**LETTER OF APPEAL TO  
THE BOARD OF SUPERVISORS**

**VR-19-1051 APPEAL TO BOARD OF SUPERVISORS**

County File(s): VR-19-1051,

Site Address/Location: 58 Canyon Lake Drive, Port Costa, California

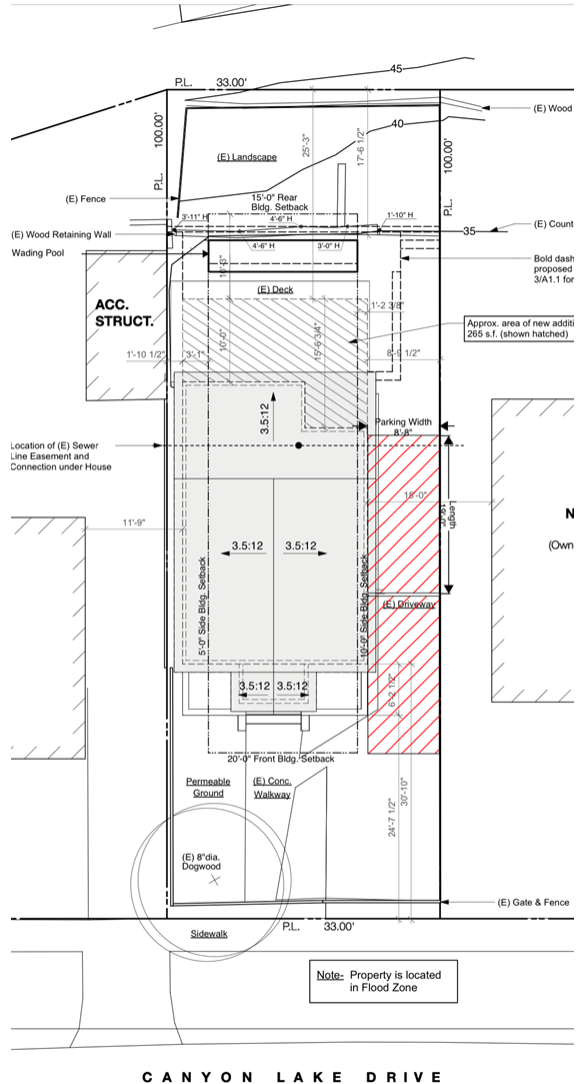
SETBACKS: The Planning Commission abused their discretion when allowing the Applicant to swap front and back yard setbacks (or principal and secondary frontages) in order to build up to 15' on Canyon Lake Drive without requesting a front yard or principal setback variance that would likely be denied. Canyon Lake Drive is the main road driving through Port Costa. While Canyon Lake Drive was correctly identified and approved as the principal setback in the ZA proposal, it was incorrectly identified and approved as the secondary setback in the PC proposal. While the ZA proposal correctly placed the front of the house behind the 20' setback on Canyon Lake Drive, the PC Proposal builds up to 15' on Canyon Lake Drive without requesting a necessary front yard variance. The PC findings were not supported by the evidence as the front of the house and driveway face Canyon Lake Drive, the main road in Port Costa. Additionally, the property has no access to Prospect Avenue a small one lane road cut into a 45-degree angled hill at the rear of the fenced off property. It is an abuse of discretion to approve an inaccessible one lane road at the rear of the property as a primary setback and the two lane road in front of the home as the secondary, especially considering the home and driveway faces the two lane road (Canyon Lake Drive). The switching of setbacks was arbitrary and capricious and produced absurd findings in which neighbors are held to more stringent front yard setbacks on Canyon Lake Drive than the applicant. Accordingly, the appellant requests the revised application for VR-19-1051 be denied due to findings not supported by the evidence and abuse of discretion regarding application of principal and secondary or front and rear yard setbacks.

to the main structure is a 20' front yard setback on Canyon Lake Drive and a 15' rear yard setback on Prospect Avenue.

The County Zoning Administrator Staff Report clearly summarizes the boundaries of the property and then properly applies the plain meaning of the ordinance as exemplified in the chart provided by the planner on page 11 of the ZA Staff report and included above.<sup>1</sup> Application of the plain meaning of the ordinance is also exemplified on the VR19-1051 Revised Drawing which was presented to the Zoning Administrator, a portion of which has been included above.<sup>2</sup> Taken in conjunction, the drawing and the chart reflect the plain meaning of the ordinance with a front yard setback of 20 feet fronting Canyon Lake Drive and a rear yard setback of 15 feet fronting Prospect Avenue.

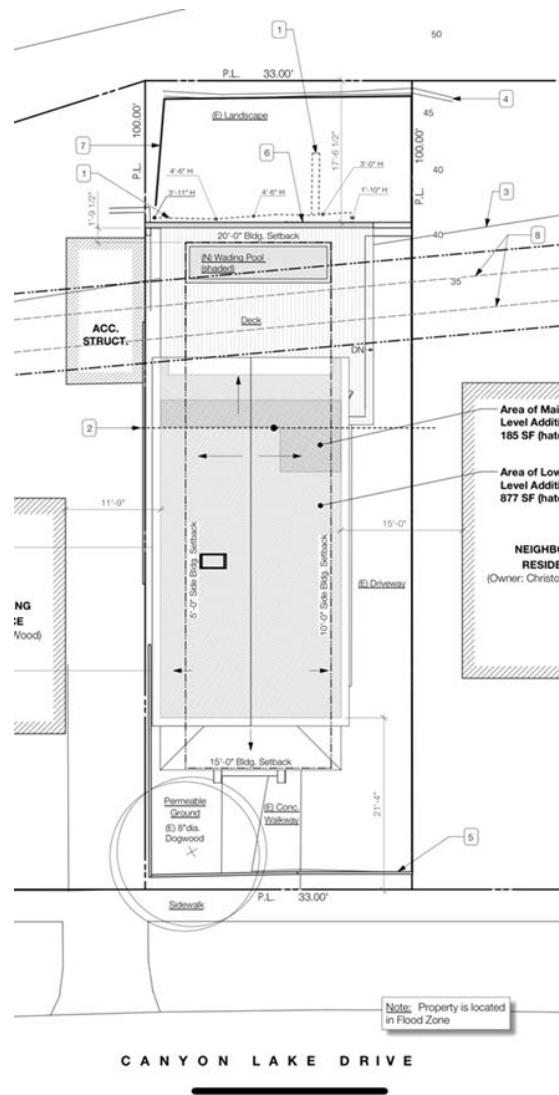
However, the Planning Commission Staff Report reinterpretation can also produce results which directly contradict the plain meaning of the ordinance. The potential for arbitrary results in the second interpretation becomes clear when considering the newly revised drawings approved by the Planning Commission, a portion of which has been included below.<sup>4</sup>

As can be seen in the Planning Commission submission, the applicant utilized the new interpretation to flip his front and back yard setbacks. The applicant designated his back-yard frontage as his "principal" frontage, thus necessitating a 20' variance. Conversely, the applicant designated his front yard as his "secondary" frontage, which he believes invalidates the necessity of a 20' front yard setback. He then proposes to build up to the erroneously reinterpreted and inaccurately applied 15' setback secondary frontage in his front yard with no request for a 15' front yard variance. Clearly, this is not consistent with the plain meaning of the ordinance which is to provide a 20' front yard setback and a 15' rear yard setback.

**CLOSED CONDUIT**

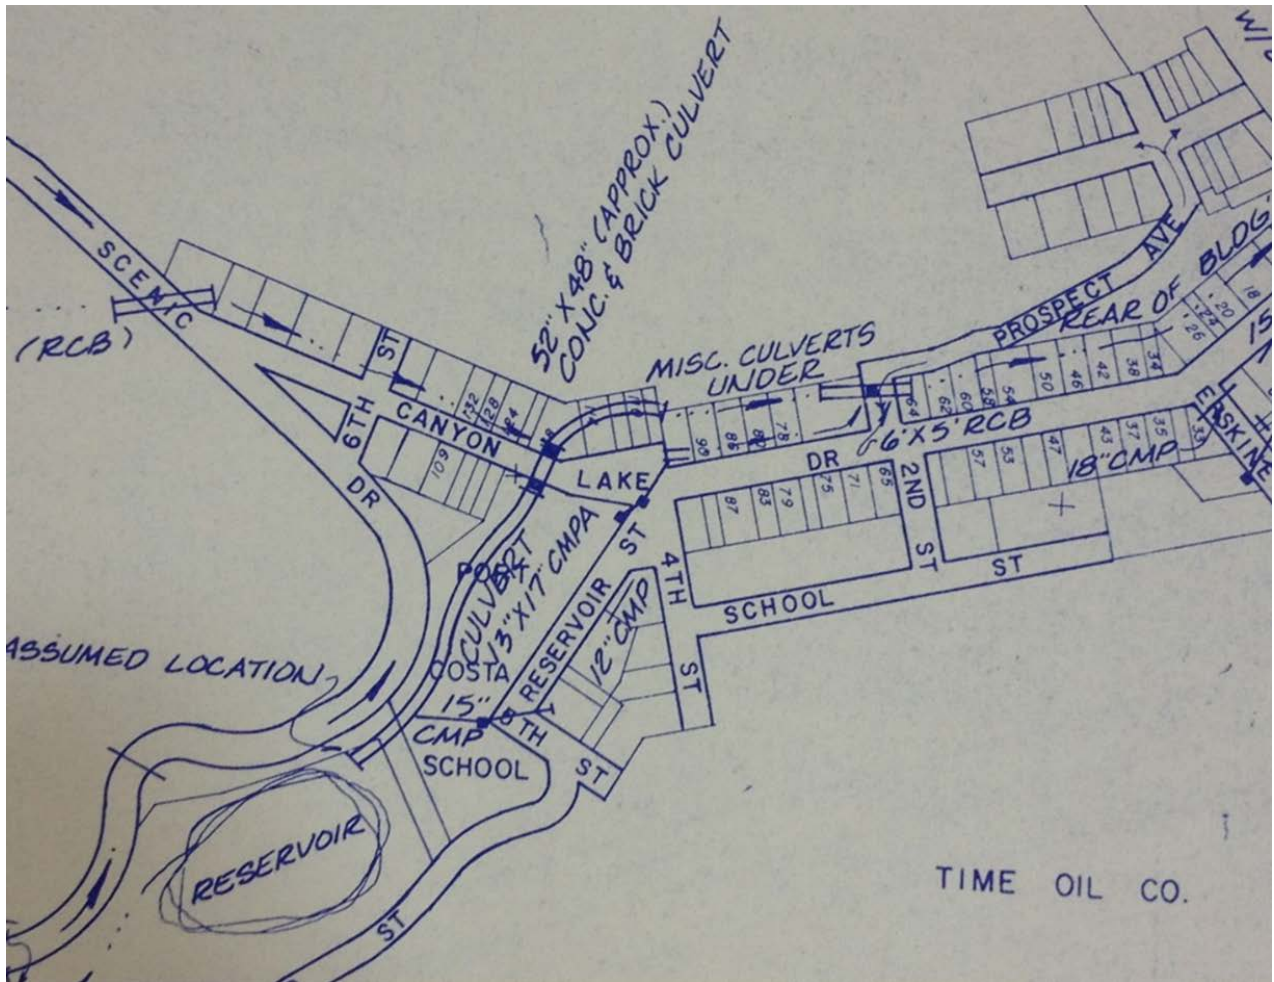
The Zoning Administrator appeal was submitted after the commenters concerns regarding the applicant's proposal to build on top of a rear yard culvert were disregarded. The applicant's original proposal, approved by the Zoning Administrator, stated no closed conduit existed in the rear yard of the applicant's home. In the Zoning administrator hearing, we provided both a hand drawn survey from public works that included the closed conduit as well as pictures of the closed conduit. We have included them again.

In the Planning Commission Staff Report, some headway was made regarding the closed conduit, and we are thankful for it. The applicant stated a 4-foot-wide culvert runs through the rear portion of the yard fronting Prospect Avenue. However, the revised drawings error in both the size and location of the culvert, thus by extension the calculation of the required easement, in a manner solely advantageous to the applicant and detrimental to the safety of the community.

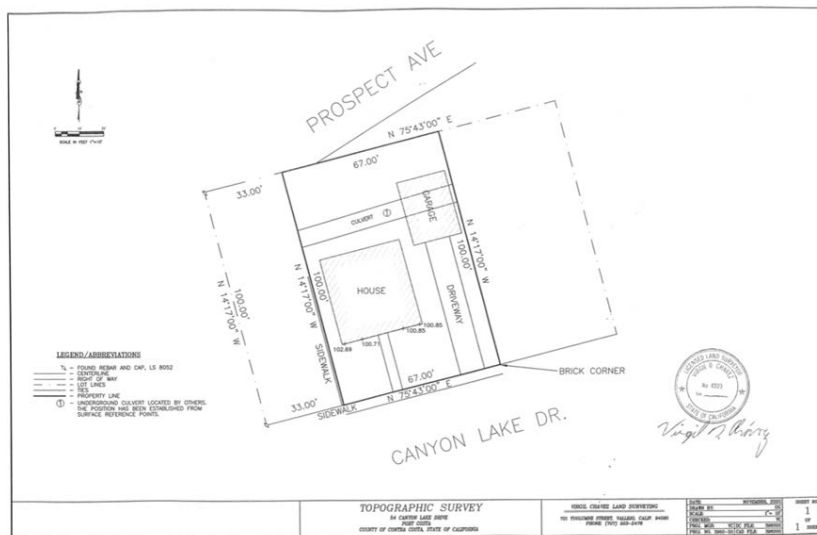
As the plain reading of the ordinance can imply a few different interpretations, the appellant puts forth the interpretation provided by Randolph Sanders, Contra Costa County Public Works Department: Engineering Services who, in an email to the appellant dated 7/7/2020, provides the example of 3' closed conduit and concludes, "the easement using the method for 3 feet outside diameter would be 9' (4.5' from centerline each side) but as that is less than 10' the easement should be 10' (5' from the centerline each side).

Accordingly, using Mr. Sanders' interpretation of the plain reading of the ordinance, a closed culvert easement should be 3' from the **outside diameter** of the closed conduit on both sides (if this totals less than 10' then the easement should be 10')
